Comments of the Keweenaw Bay Indian Community in Opposition to the Issuance of an Underground Injection Control Permit to Kennecott Eagle Minerals Company (Application No. MI-103-5W20-0002)

Prepared for:
Keweenaw Bay Indian Community
16429 Bear Town Road
Baraga, MI 49908

Ann S. Maest
Stratus Consulting Inc.
PO Box 4059
Boulder, CO 80306-4059
303-381-8000

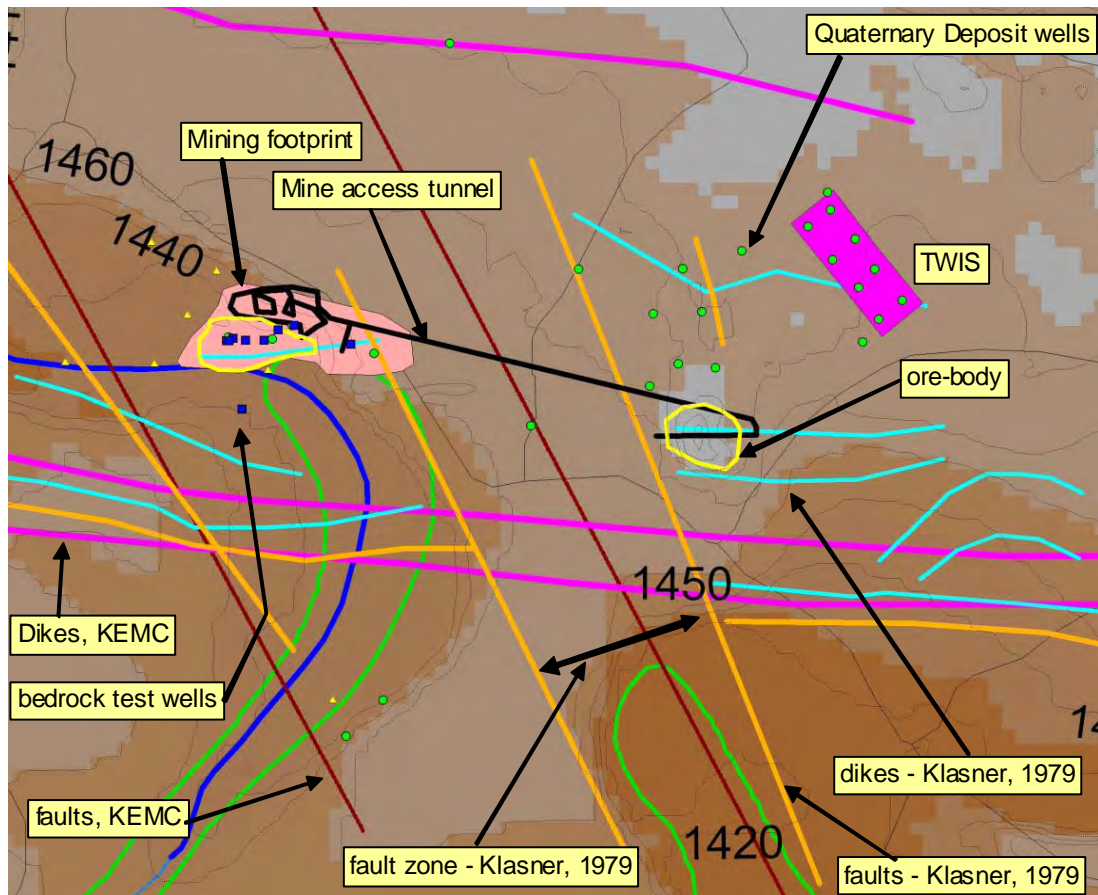
The number and locations of boreholes are inadequate to characterize the structurally complex bedrock hydrogeology in the area. Figure 2.1 shows the location of bedrock wells and boreholes. The same number of boreholes was used to characterize the smaller area affected by dewatering and the larger modeled area [over 87 square kilometers (km^2)]. KEMC apparently drilled many more “exploratory” boreholes but did not provide the information from these boreholes for review or use it to develop the geologic framework for the modeling of mine inflow.

- ▶ *Faults:* Major faults, extending for miles, have been mapped through an area potentially impacted by dewatering and the modeled 87- km^2 area (see Figure 2.1). Faults generally tend to trend north-south. These faults were mapped by KEMC’s own geologists but were largely ignored in their characterization of the bedrock geology and the Golder model. Klasner et al. (1979) also mapped faults throughout the area, and their fault locations, extent, and orientations are generally consistent with those of KEMC’s geologists.
 - Klasner described a 500-meter (m) wide fault-zone trending northwest-southeast, just east of the mining area, that actually goes through the proposed access tunnel. KEMC did not describe or consider this major fault zone in their characterization of bedrock geology.

- ▶ *Dikes*: Numerous dikes that extend through the area (mainly trending east-west, as shown in Figure 2.1) likely influence the flow through the bedrock aquifer. Dikes typically act as low-permeability features and prevent or minimize cross-flow. However, they often have high-permeability brecciated zones oriented parallel to their planes (Kruseman and de Ridder, 1991). KEMC's own cross-sections acknowledge their existence (see, e.g., Foth & Van Dyke, 2006a, Vol. 2, App. B-5, Figures 15 to 18), but KEMC made no attempt to characterize these features and their potential influence on natural groundwater flow, or on infiltrating TWIS discharge. Cadmus (2008a, pp. 17, 21) correctly pointed out that KEMC did not consider the effects of dikes in their analytical or numerical analysis (Foth & Van Dyke, 2006b, App. E-2 and E-3, respectively). The presence of dikes can significantly reduce flows perpendicular to them, but it can also dramatically increase flows along them. This could dramatically increase mine inflows. In fact, the Salmon Trout River, as it flows to the north, abruptly changes direction when it intercepts the Peridotite dike, and then realigns itself parallel to the dike. The river itself provides an ample supply of water for inflow into the mine via the dike, yet KEMC never assessed this major hydrogeologic feature.

KEMC did not consider faults and dikes in test well placement. It is standard hydrogeologic practice to evaluate the hydraulics of these features (Kruseman and de Ridder, 1991). When these types of features are present, pumping, monitoring, and response wells should be placed on either side of the features to test whether water across the features is in hydraulic communication. KEMC's test well placement was too localized (over the ore-body), and the locations of the pumped bedrock wells (107 and 084; see Figure 2.2) did not adequately test major water-conductive features over the area that may be affected by mine dewatering (see Figure 2.1).

Figure 2.2. Location of wells and response to hydraulic testing.

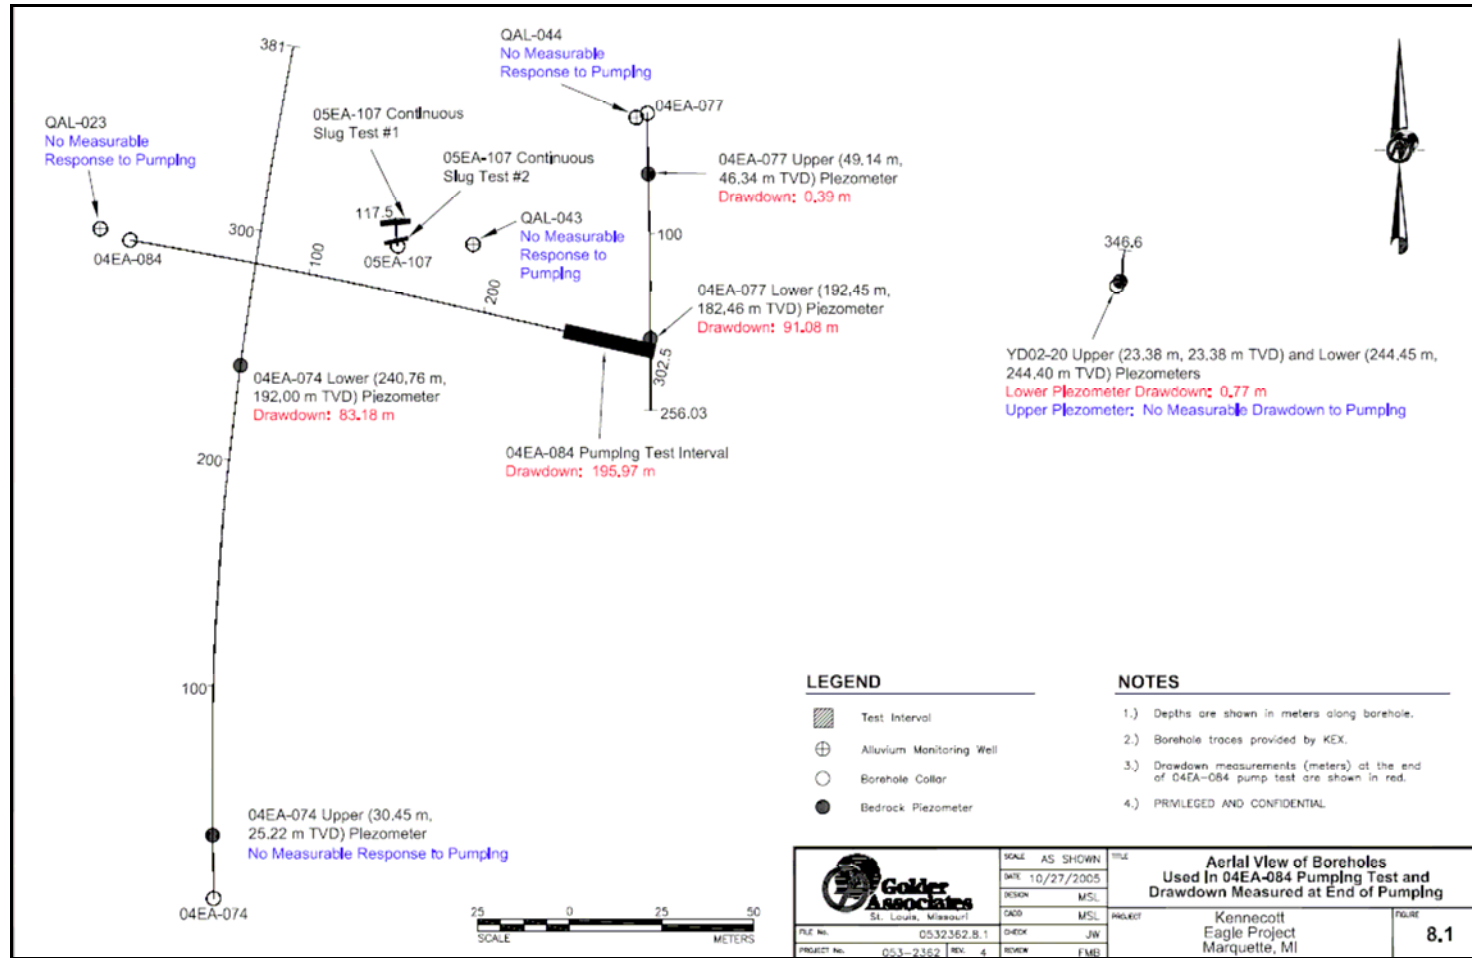
KEMC modeled drawdown over a wide area that included several major structures such as faults and dikes (see Figure 2.1). However, drawdown was modeled based on hydraulic testing of the bedrock that was too localized and covered only a small area, largely within the ore-body, as shown in Figure 2.1 (green squares). As shown in Figure 2.1, only one bedrock testing well was located outside of the immediate ore body area. A much wider area should have been tested, including the area that will potentially be affected by groundwater drawdown from mine dewatering. There were two phases of hydraulic testing: one in 2005 that included four slug tests; and one in 2006 that only included one multi-well pump test (with well 084 as the pumping well). The results of this pump test are shown in Figure 2.2.

No bedrock wells were monitored north or south of the pumped wells (107 and 084; see Figure 2.1) e.g., in the area of the proposed underground workings or south of the Salmon Trout River. Testing in these areas would have helped estimate the extent of drawdown and hydraulic communication across the river and across a known dike and possible fault.

Wells east and west of pumped well 084 showed a clear and large response to pumping. Wells 074 and 077 showed a drawdown of 83.2 and 91.1 m, respectively (see Figure 2.2). Given this large response, wells should have been tested that were much farther away in all directions from the pumping well, including across known faults and dikes, to estimate the complete extent of response in the bedrock aquifer. Only one bedrock test well was monitored just outside and east of the immediate ore-body area (YD02-020), yet KEMC predicted that the areal extent of mine dewatering (more than 1 foot at more than a mile from the ore-body – see Foth & Van Dyke, 2006a, Vol. 2, App. B-4, Figures 9.4 and 9.5) will extend far beyond the distance to this well. The well intercepts several major structures (dikes and faults) that KEMC did not hydraulically test. Therefore, KEMC's predicted mine inflow and impacts to groundwater levels in the bedrock and Quaternary aquifers beyond the area of hydraulic testing are highly uncertain.

One slug test was performed in well 107 (see Figure 2.2 for location of the well). Slug tests are known to produce less accurate and very localized results compared to long-term pump tests, and the results are biased toward underestimating true permeability (Butler and Healey, 1998).

Figure 2.3. Transmissivity vs. time during the pump test at well 084. Transmissivity increases from top to bottom on the y axis.

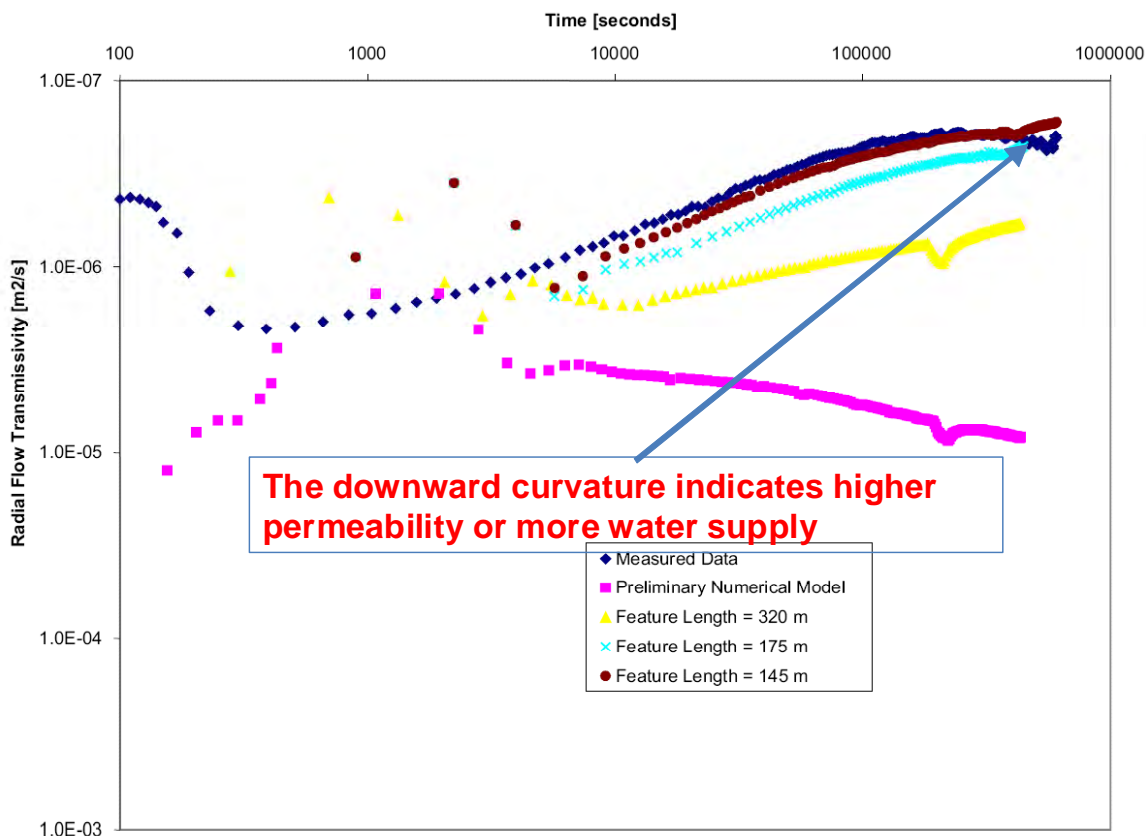
Figure 2.3 clearly shows that the simulated drawdown for the conceptual model with 145-m faults (brown circles) does not reproduce the important trend of increasing transmissivity in the measured data (blue diamonds) near the end of the seven-day test. The data indicate that the transmissivity beyond seven days would continue to increase, yet results of the 145-m simulation shows transmissivity decreasing abruptly before the end of seven days. If KEMC had conducted a longer pump test (e.g., one month) and attempted to match this later portion of the test, they would have had to significantly increase fault lengths. Results of their pump testing do not provide an adequate basis for assuming that the 145-m long faults are vertical or oriented north-south. In fact, the monitoring wells experiencing the most drawdown during the 04EA-084 pump test were actually located to the west (well 04EA-074) and east (wells 04EA-77, YD02-20).

Figure 2.4. Geophysical logs for well 04EA-54 showing the behavior of fluid conductivity with depth.

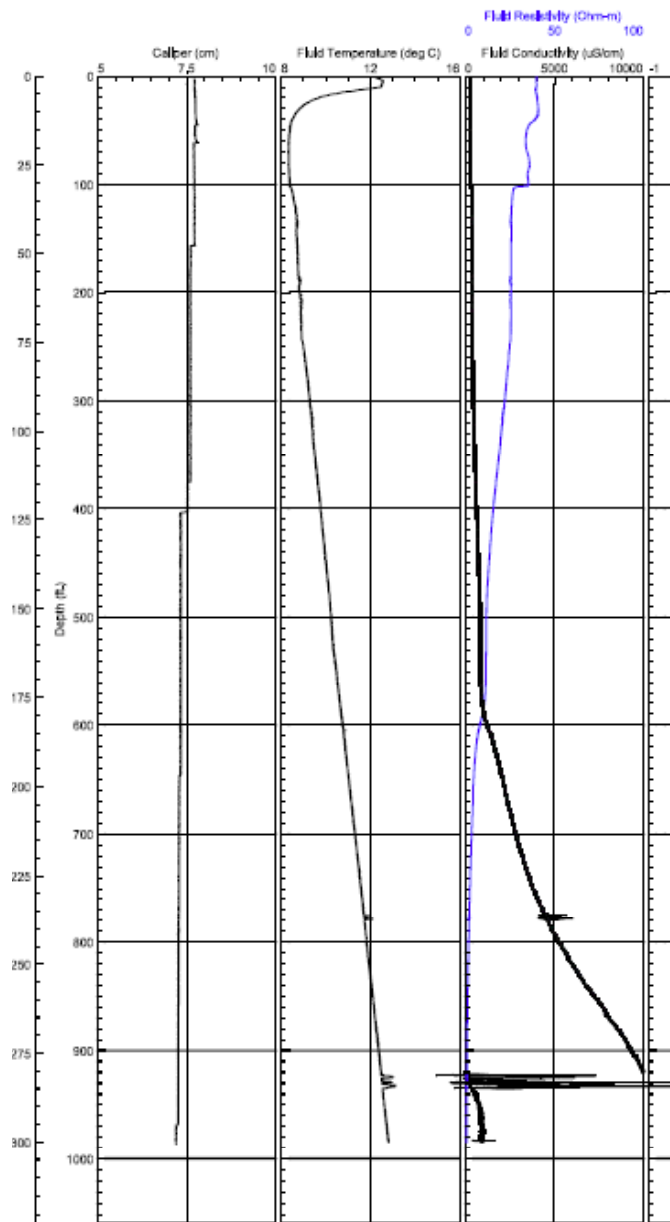
EC (which can be converted to density) information is available from geophysical logs (an example is shown in Figure 2.4), but KEMC suggested that these results were compromised by drilling fluids and fresh water flushing, and interpretation can only be qualitative (see Foth & Van Dyke, 2006b, Vol. 2, App. B-2, p. 12). Although this may be true, results from the EC logs (Foth & Van Dyke, 2006b, Vol. 2, App. B-2, Figures 3-1 to 3-6) are inconsistent with both KEMC's interpreted density profile and their conceptual model (Foth & Van Dyke, 2006b, Vol. 2, App. B-3, Figure 10.2 and pp. 40-41), which suggests that TDS increases at the upper-lower bedrock interface. For example, EC logs for boreholes 04EA-047 and 04EA-054 (Figures 3-1 and 3-2) show much higher values [$> 12,000$ micro-mhos per centimeter

Figure 2.6. Isopach (thickness) map (ft) of the B/C confining units and Quaternary aquifer monitoring wells, with zones indicated in well ID. Wells in red were used for hydraulic testing.

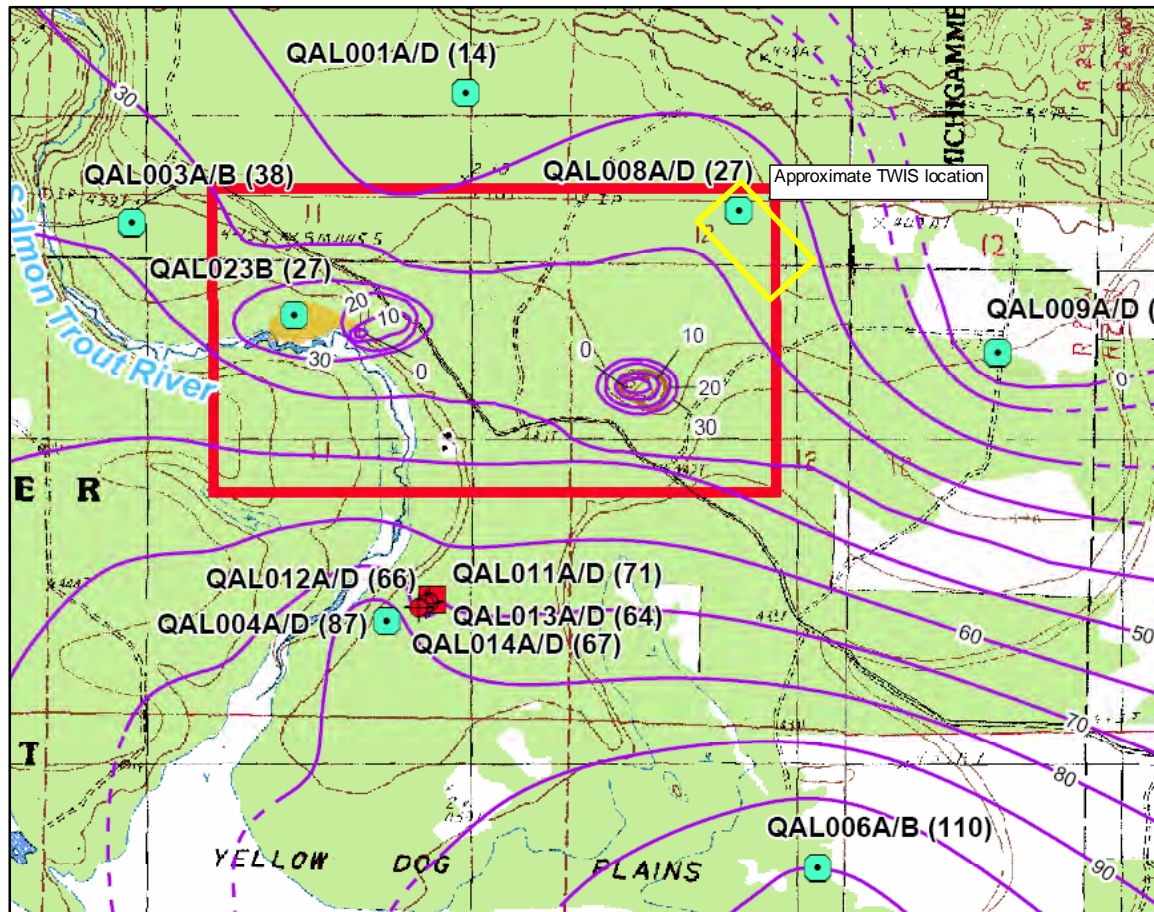
Wells used for testing the extent of hydraulic communication between the A and D aquifer zones were located in areas far away from expected mine dewatering and TWIS discharge (see red symbols in Figure 2.6). The thickness of the confining zones (B and C) in the areas tested ranges from 61 to 87 ft, whereas the thickness in the mine area ranges from only 0 to 30 ft. The thickness of the confining B/C units is also much greater in the test area than beneath the TWIS, where it is assumed to pinch out completely. It is misleading to conduct tests in an area where the thickness of low permeability material between two aquifers is much larger than in the areas of interest. Testing conducted in areas where the B/C units are relatively thick erroneously leads KEMC to conclude that low conductivity sediments will severely limit the movement of groundwater between the A and D zones, and that the D zone acts as a confined aquifer in the test area. If the same testing were conducted in key areas of interest (near the ore-body, where bedrock outcrops at the surface, or near the TWIS where KEMC claims these units pinch out), these conclusions would be different. KEMC has made no attempt to conduct the appropriate testing in these key areas.

Figure 2.7. Isopach (thickness) map of the Quaternary deposit.

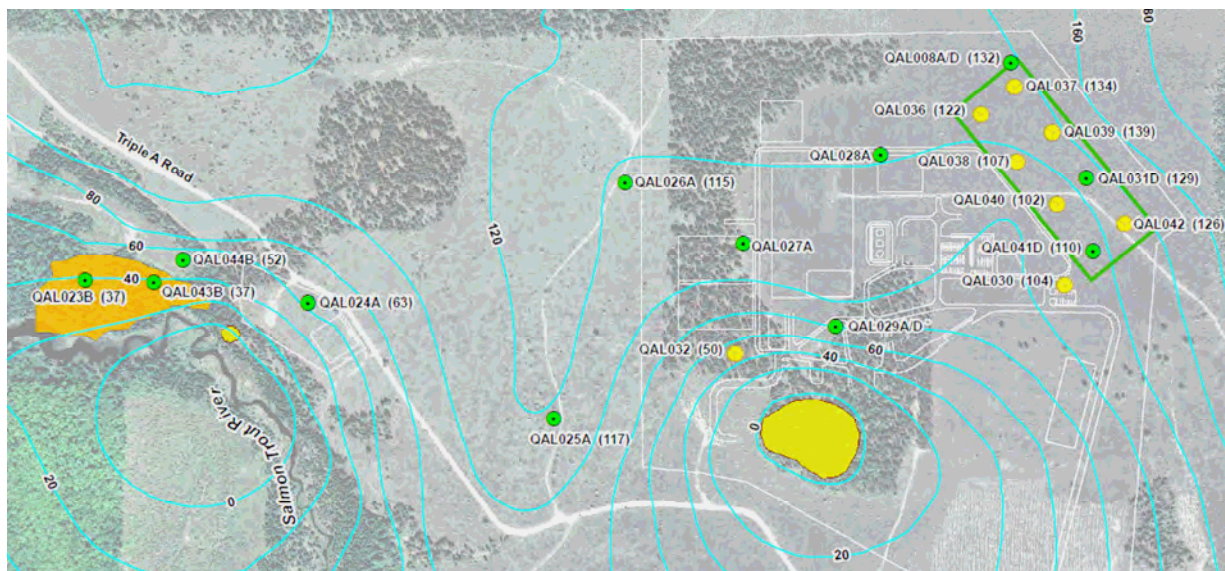
- ▶ KEMC did not test the connections between the Salmon Trout River and the bedrock. The thickness of unconsolidated material is highly variable, especially over the ore-body, and in places does not exist (Figure 2.7). Figure 2.7 shows an absence of unconsolidated material at the ore body, extending for some distance beneath the Salmon Trout River. This figure clearly indicates that the Upper Bedrock aquifer is in direct contact with the river/wetland area, yet KEMC installed no monitoring wells in this area to test the degree of hydraulic connection between the river (or nearby areas where Quaternary deposits thin) and underlying bedrock zones. None of the groundwater flow models considered what likely represents a direct flow conduit from the river into the bedrock system. Under current natural conditions, this conduit may not manifest itself in a notable fashion, but under full mine-dewatering conditions, this area could act as a local drain for the nearby wetland and river.

Figure 2.8. Overlay of mine levels (left side of diagram) and the main access tunnel (“main decline”) with simulated water level from drawdown. Mine will have to be dewatered to the lowest level to access all the ore.

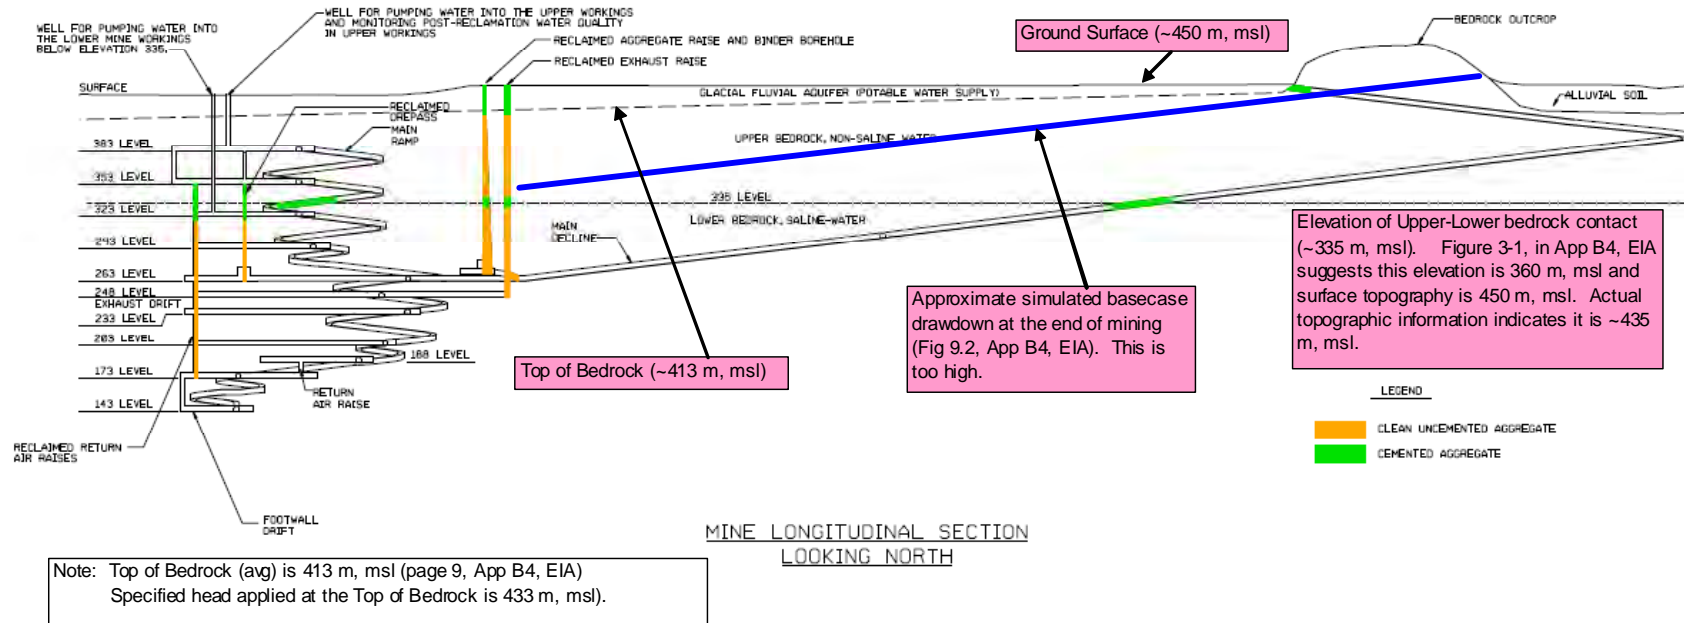
5. *Groundwater inflow estimates will not allow the mine to dewater completely.* Golder used the FEFLOW model and estimated groundwater inflow rates to predict groundwater head or levels during mining, as shown in Figure 2.8. When these simulated heads are compared to the mine levels and the access tunnel elevations (Figure 2.8), it is clear that the heads are much higher than the level of the access tunnel. In other words, Golder's model predicts that water levels will not be low enough to mine the entire ore body. Mine inflow rates for both the base-case and upper bound exhibit this problem. This demonstrates that Golder's groundwater inflow rates to the mine are too low, and therefore, that the estimates of inflow to the WWTP and the TWIS are too low.

- ▶ Increasing the mine inflow to actually dewater the entire portal decline and mine area (see Figure 2.8)
- ▶ The potential for crown-pillar failure or rock mass dilation and resultant increase in mine inflow
- ▶ Inflow from the Salmon Trout River directly over the mine
- ▶ Inflow from brecciated dike zones.
